**PRODUCT SERVICE ADVISORY**

**RSLogix 5000, version 16.00.00**

**When used with SoftLogix5800 or RSLogix Emulate 5000, Versions 16**

Ref: ACIG 2007-07-001

Example 1: Directly-addressed Member Array Use

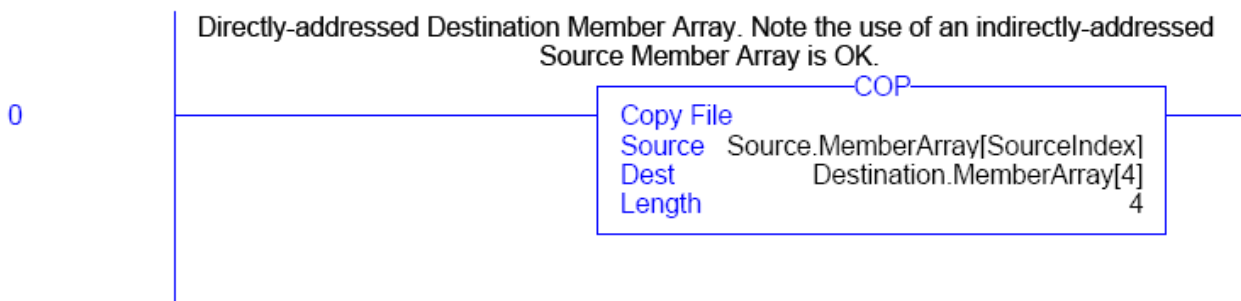
This sample code would work properly because the destination member array used in the instruction is directly-addressed.

Example 2: Indirectly-addressed Member Array Use

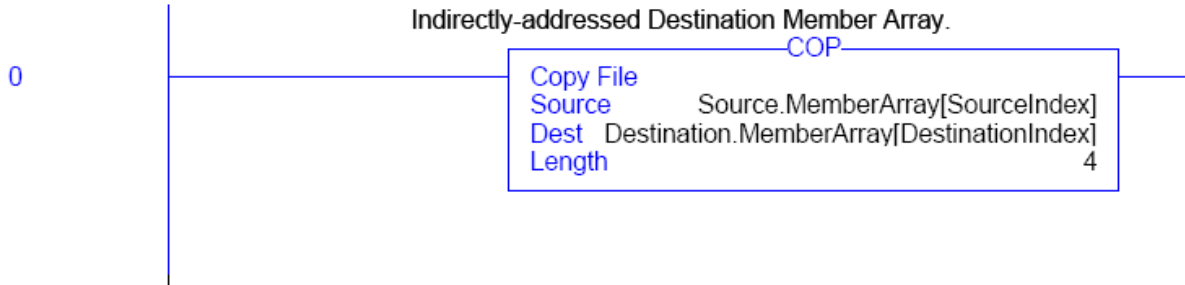
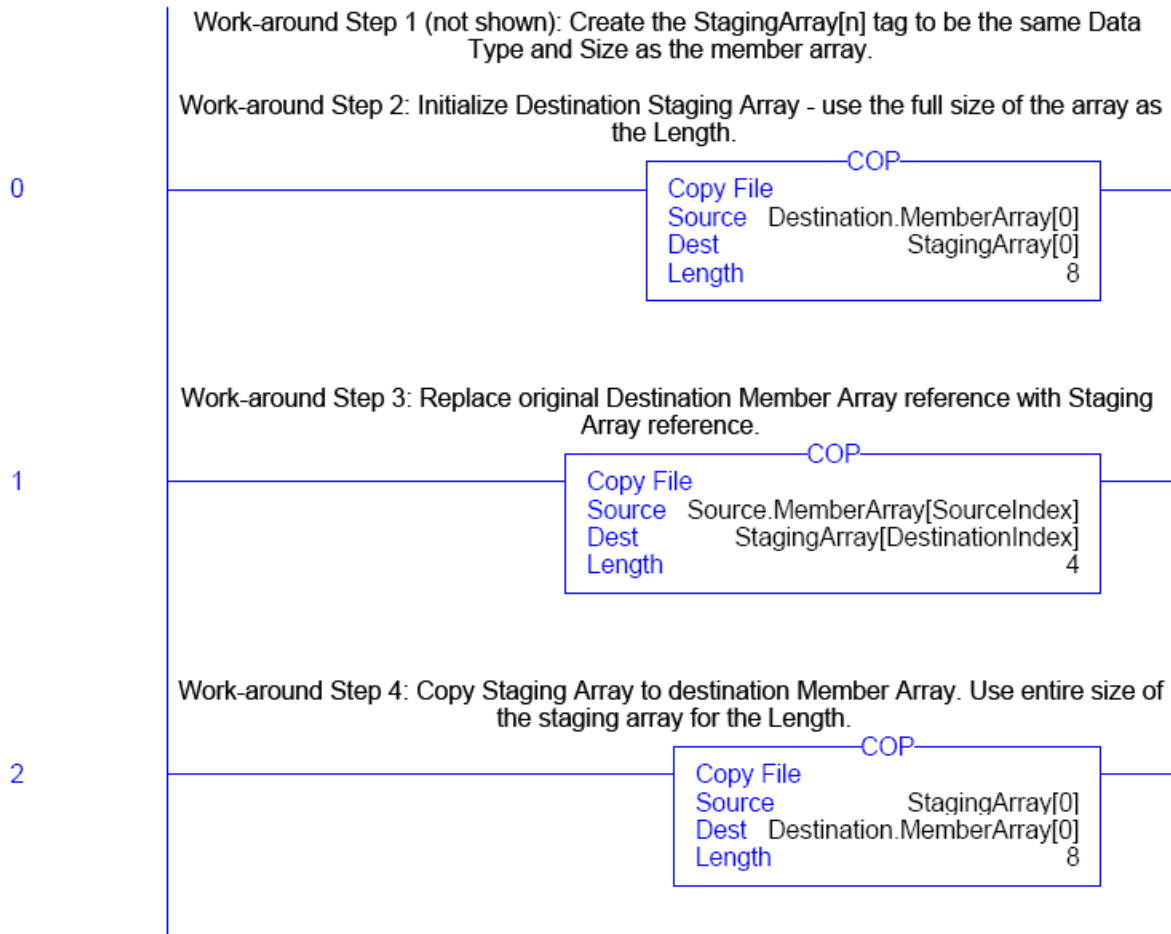
The use of this sample code would result in anomalous behavior because the member array is indirectly-addressed.

Example 3: Temporary Workaround to Correct Example 2

In order to work around the use of an indirectly-addressed, destination member array used in example 2, use a staging array as shown.
